Addendum No. 001

Subject: George W. Childs School – Classroom Modifications
SDP Contract Nos. B-071C, B-074C of 2017/18

This Addendum, dated May 9, 2018, shall modify and become part of the Contract Documents for the work of this project. Any items not mentioned herein, or affected by, shall be performed strictly in accordance with the original documents.

DRAWING NO.
E122

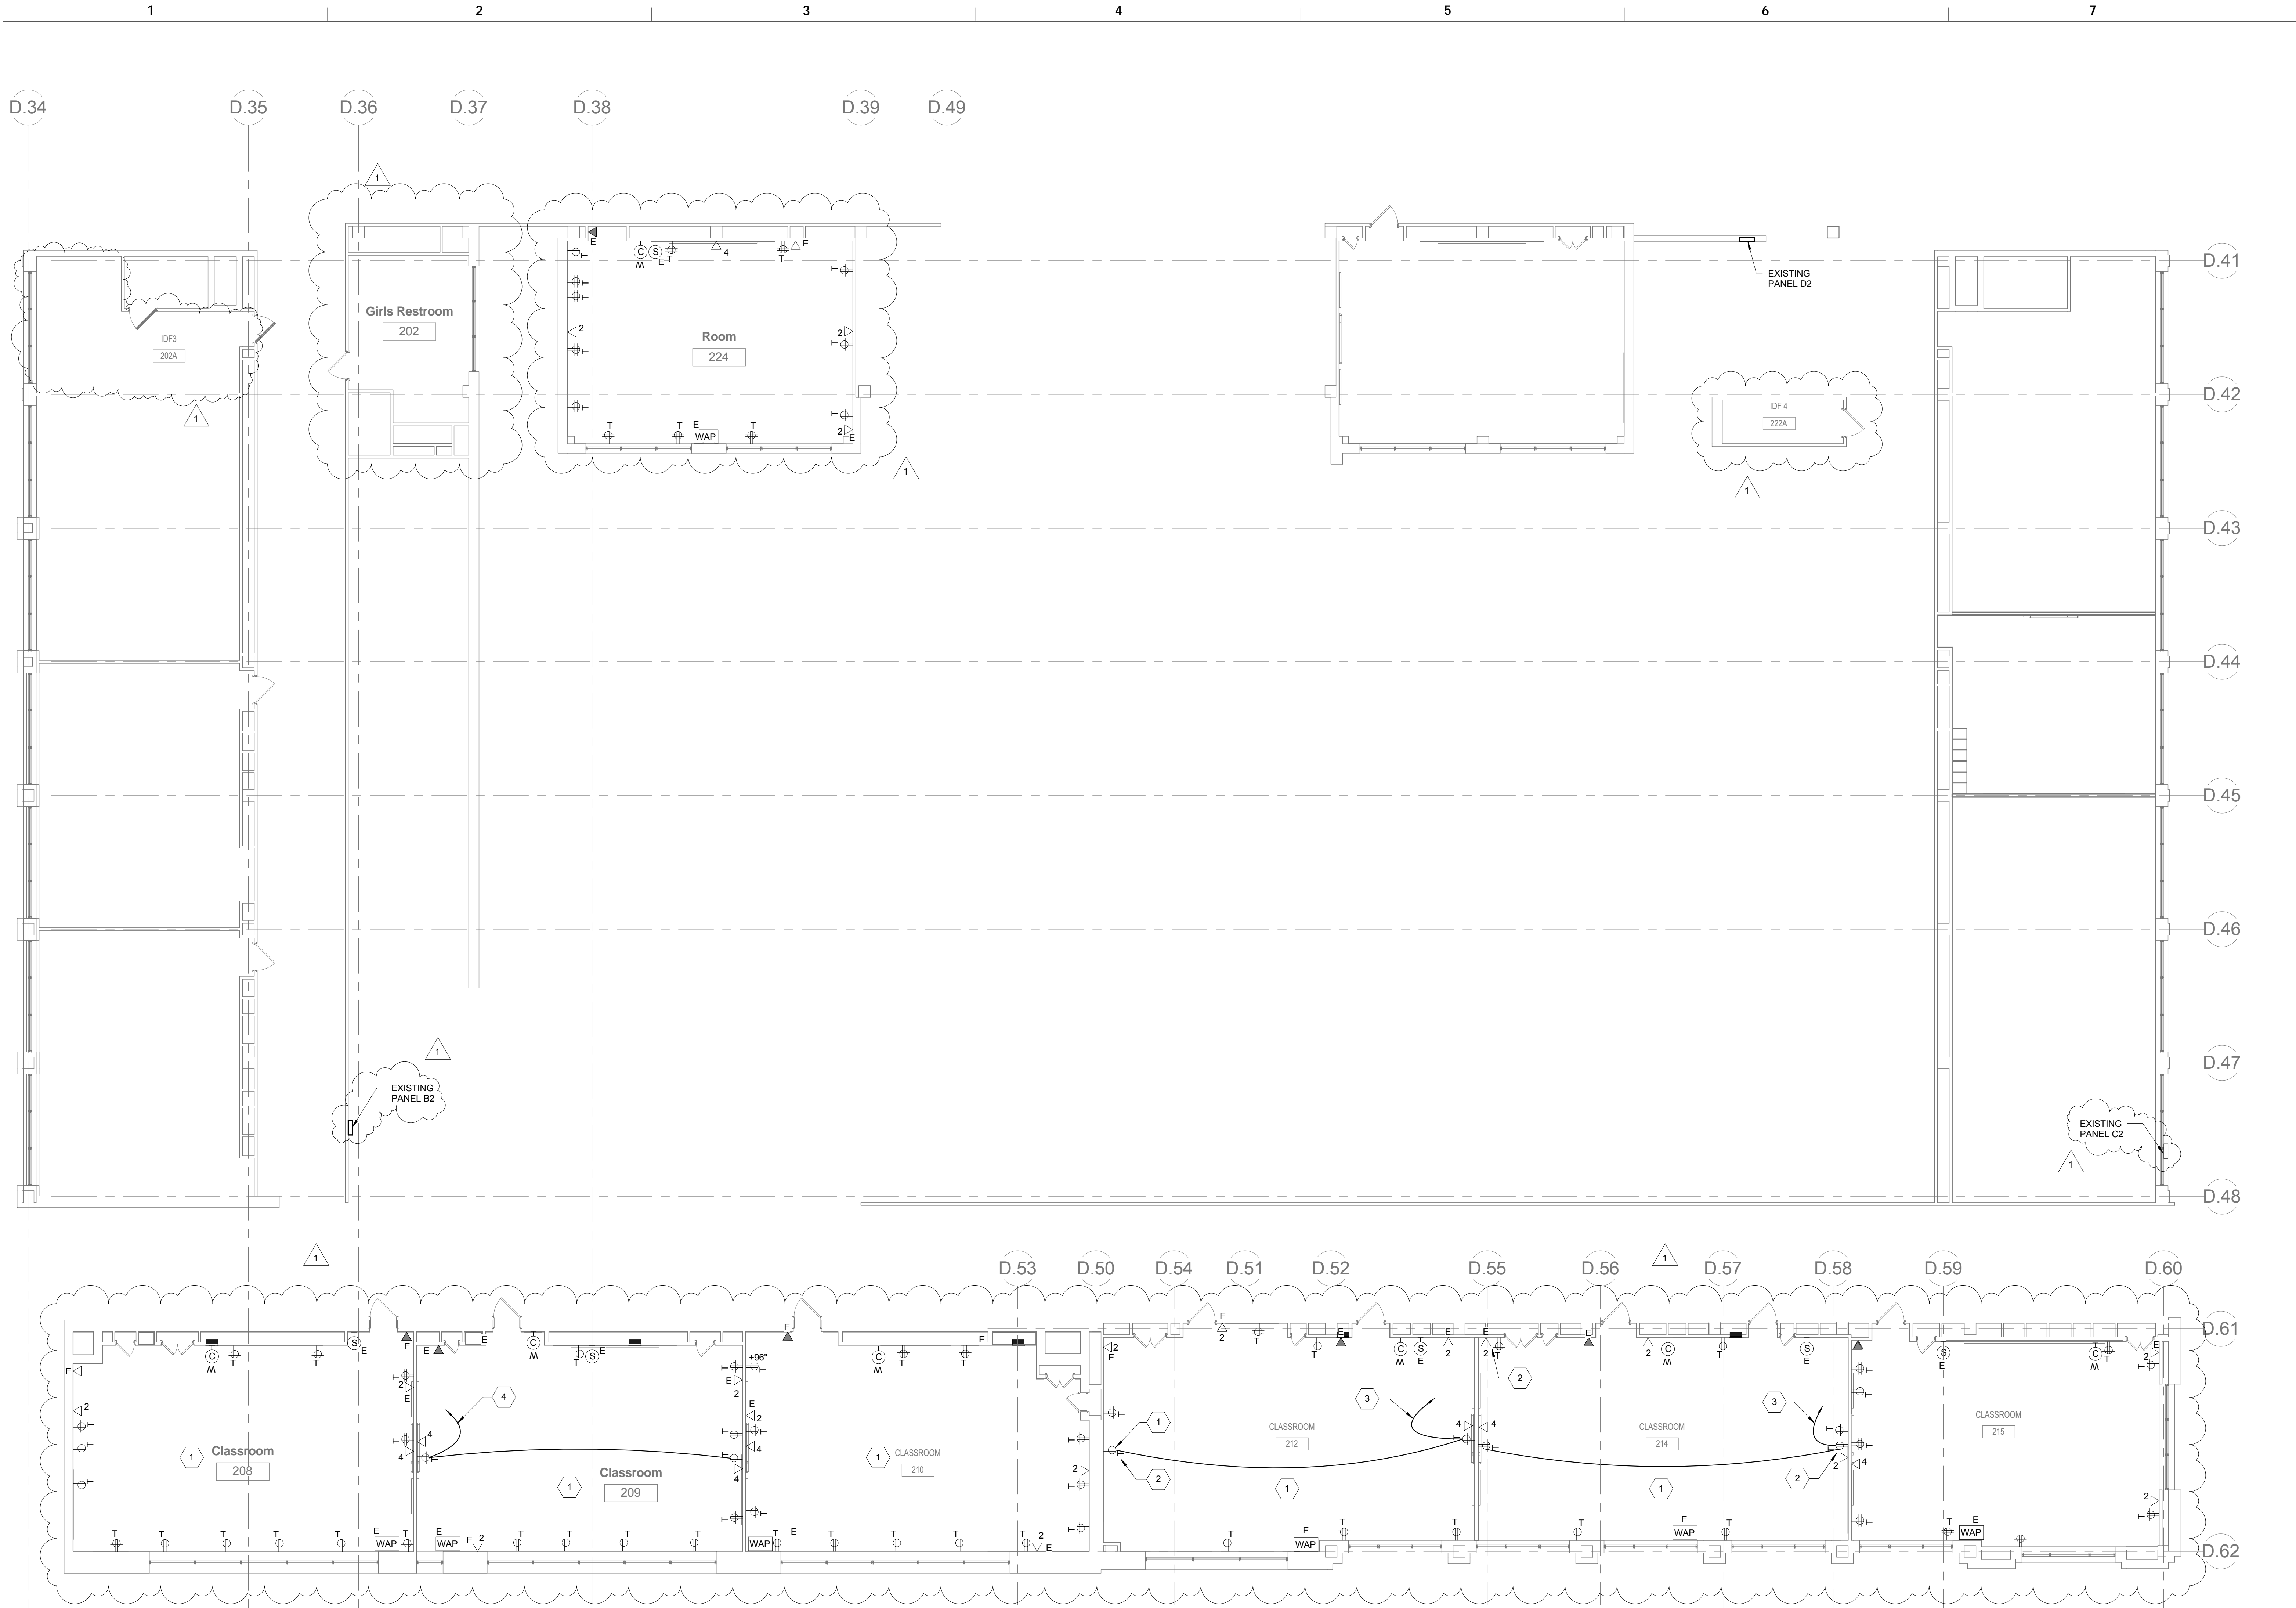
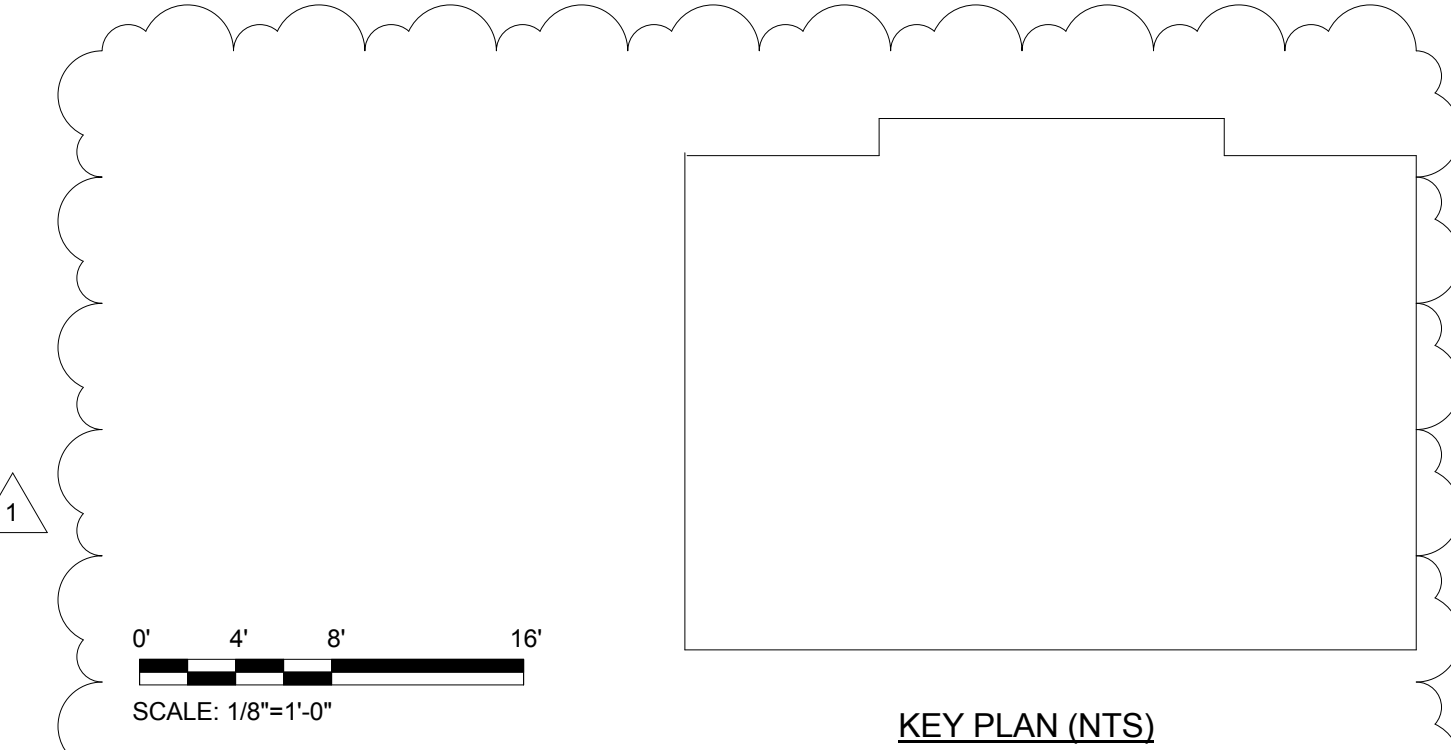
- a. Added new receptacle and data layout in rooms 208, 209, 210, 212, 214, 215 and 224.
- b. Added IDF3 room 202A, IDF4 room 222A and Girls Restroom 202. Added key note 3 and 4.
- c. Added key plan, graphic scale and north arrow

1 DATA RISER DIAGRAM
NTS

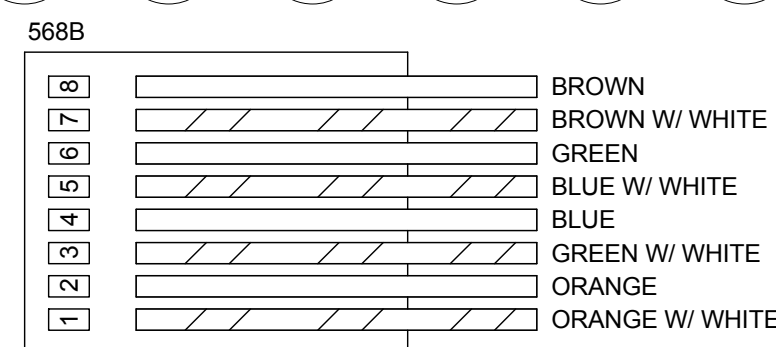
- a. Deleted panelboard cover detail.
- b. Added note to data riser diagram.

10. **Question:** Detail 1 drawing E301 shows (2) 2-jack data outlet and (1) 4-jack data outlet for each classroom; however these symbols with the D2 and D4 subscripts don't appear on the new work drawings. There are some data outlets shown with the subscript "2" for 2 data lines, but they don't appear in all the classrooms. Most of the data outlets are shown with a tag "E" for existing to remain. Please clarify design. Is each classroom supposed to get a (1) 2-jack data outlet and (1) 4-jack data outlet? If so please locate these devices on the floor plans.

11. **Question:** Is each classroom supposed to get (1) 2" EMT conduit back to the data rack per detail 1 drawing E301?

12. **Question:** Detail 1 drawing E301 says a note about an existing data racks in MDF and IDF, but does not state whether the cables are supposed to go the MDF or IDF. Also the MDF and IDF rooms are not labeled on the floor plans. Please clarify where the existing data rack is located on the floor plan and whether the MDF or the IDF rack contains the rack mounted master clock.

Response: Yes, each classroom requires a minimum of (1) 2-jack data outlet and (1) 4-jack data outlet. Will locate data outlet location.

Response: Detail 1 on drawing E301 is a typical detail, contractor may combine Cat 6 cables to a 2" inch conduit not to exceed allowable conduit fill.

Response: Note on detail 1/ E301 indicates "PROVIDE NEW PATCH PANEL TO MATCH EXISTING AND COORDINATE WITH OWNER PRIOR TO INSTALLTION TERMINATE EACH CABLE AT NEW PATCH PANEL". Room names and numbers are indicate on detail 1/E301. Existing Master clock is not located in existing MDF/IDF rooms, the existing wired master clock is to remain since all the classrooms are not being renovated. The new wireless clock shall be located as shown on detail 1/E301.
